AMENDMENTS TO THE DRAWINGS

Attorney's Docket No.: 109897-129946 Page 4 of 7
First Named Inventor: Richard B. Keller Application No.: 09/884,312
Title: FAST CYCLIC REDUNDANCY CHECK (CRC) GENERATION REPLACEMENT SHEET

Figure 4b

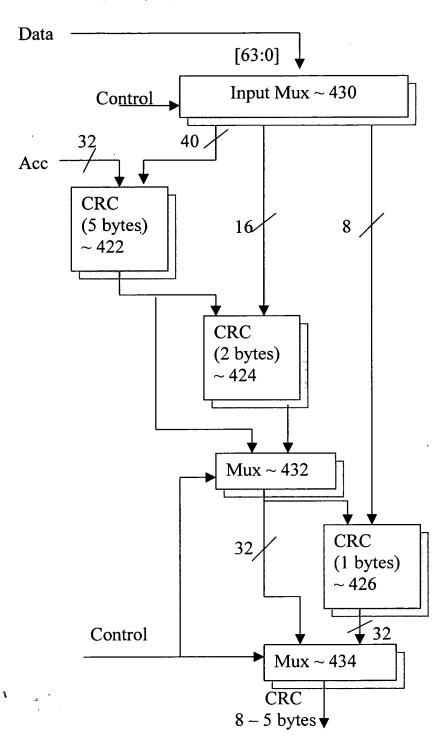
In Fig. 4b, the input bit distribution has been changed from "[64:0]" to "[63:0]".

Figure 5a

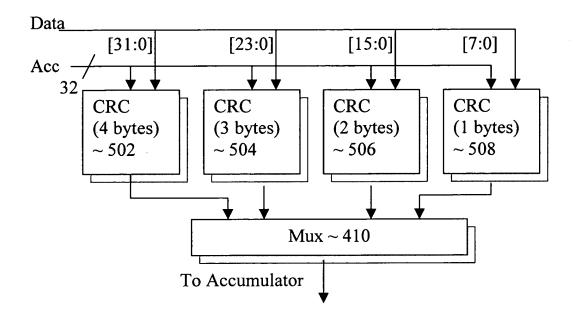
In Fig. 5a, the input bit distributions have been changed from "[63:0]", "[56:0]", "[48:0]", and "[40:0]" to "[31:0]", "[23:0]", "[15:0]", and "[7:0]", respectively.

Figure 5b

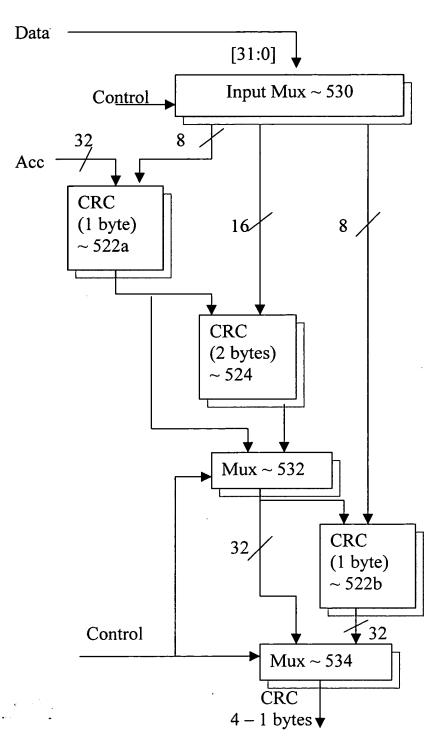
In Fig. 5b the input bit distribution has been changed from "[64:0]" to "[31:0]" and the bit capacity of the line from 530 to 522a has been changed from "40" to "8".
